THE CLEVELAND ELECTRIC ILLUMINATING COMPANY

April 29, 1982

Perry Nuclear Power Plant
Docket Nos. 50-440; 50-441
Response to Request for
Additional Information -
Management Organization

CHANGES TO THE NUCLEAR ENGINEERING DEPARTMENT SINCE THE JANUARY REVIEW:
DEPARTMENT ORGANIZATION AS OF MAY 1, 1982

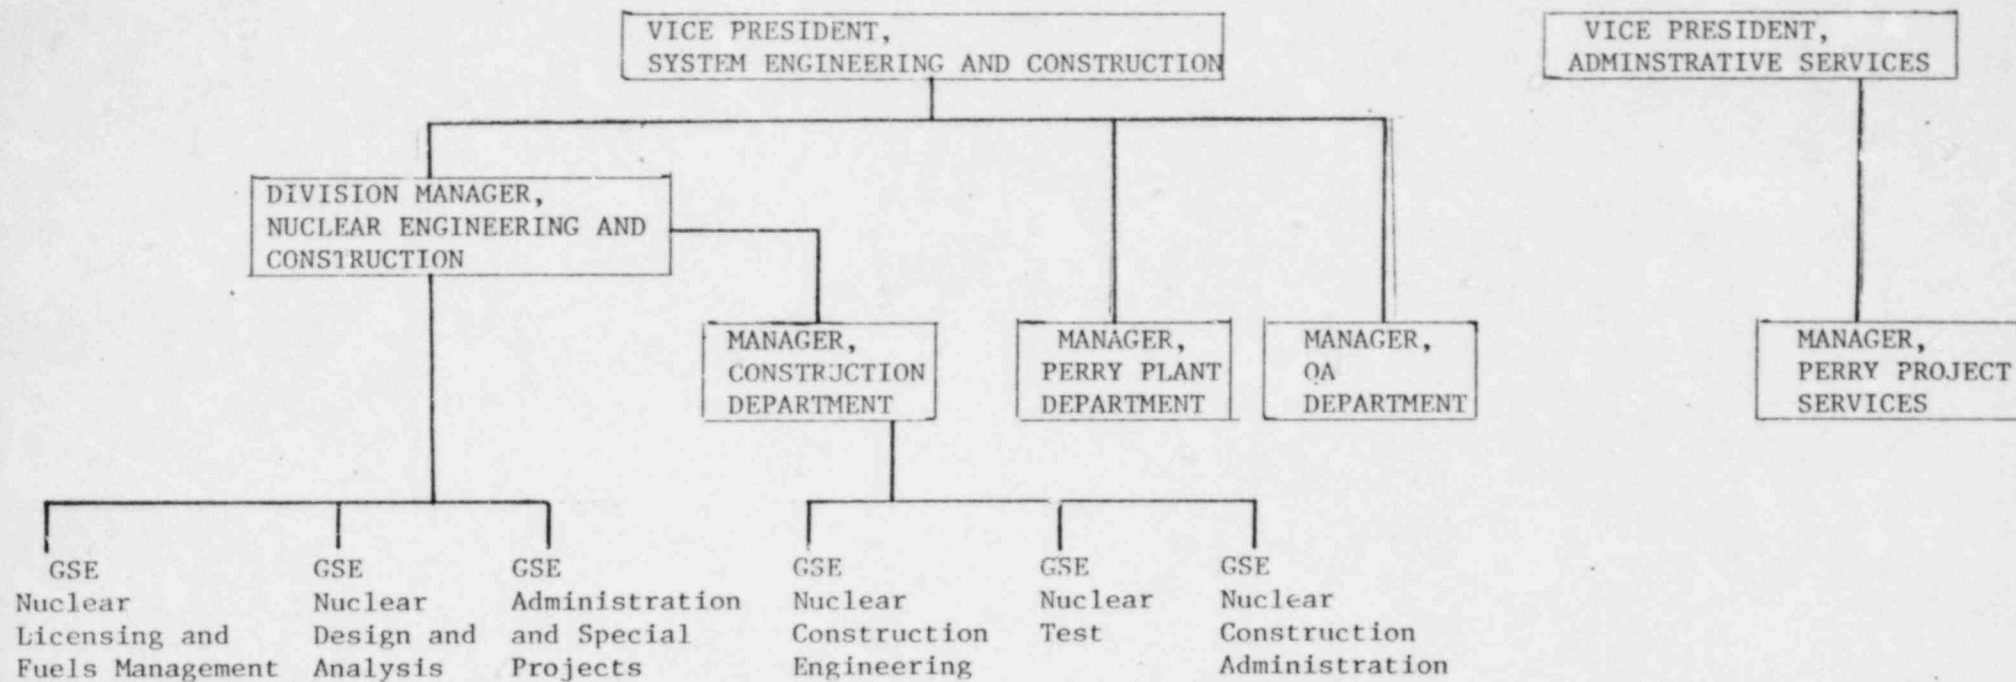
Letter of Commitment on the Reorganization
Plan for PNPP

2. As of March 12, 1982, the Nuclear Engineering Department's position of General Supervising Engineer (GSE), Nuclear Design and Analysis has been split to form two GSE positions: GSE, Nuclear Construction Engineering section; and GSE, Nuclear Design and Analysis section. The attached organization chart shows the changes which have occurred.

3. On April 21, 1982, additional changes were announced with the reorganization effective on May 1, 1982:
The Nuclear Engineering and Construction Division and the Nuclear Construction Department in that Division were formed. The Nuclear Engineering Department was discontinued and the Nuclear Construction Section was renamed the Nuclear Construction Administration Section, Nuclear Construction Department. Certain section reporting responsibilities changed as shown in the attached organization chart.
